Access Compliance Report

Public Rights-of-Way

(Pedestrian Signals)

Intersection ID: N/A	Main Street:	Cross Street: N/A	Location: N/A
ADA ID: EC6B2267143D	Signal Type: Two Push Buttons-APS	Overall Compliance: No	Severity Score: BTN 1:N/A BTN 2: N/A No BTN: N/A
Codes/Mitigation Info/Possible Solution		Field Measurements/Component Compliance

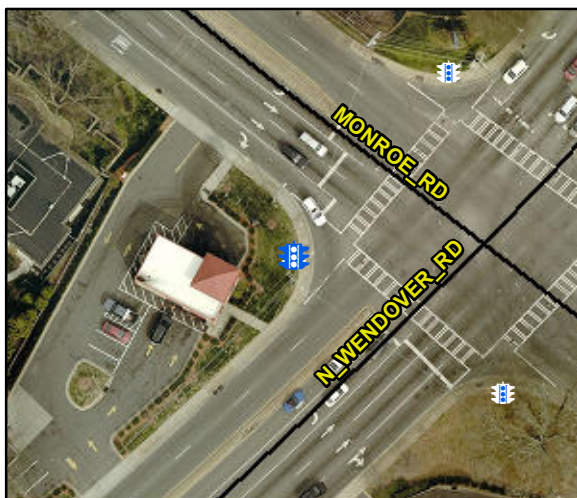
Possible Solutions: Replace Signal Push Button With APS Button on New Post. Remove & Relocate Sign.

PROW/ADA: TMUTCD 4e.08, R404.2, R406.2,
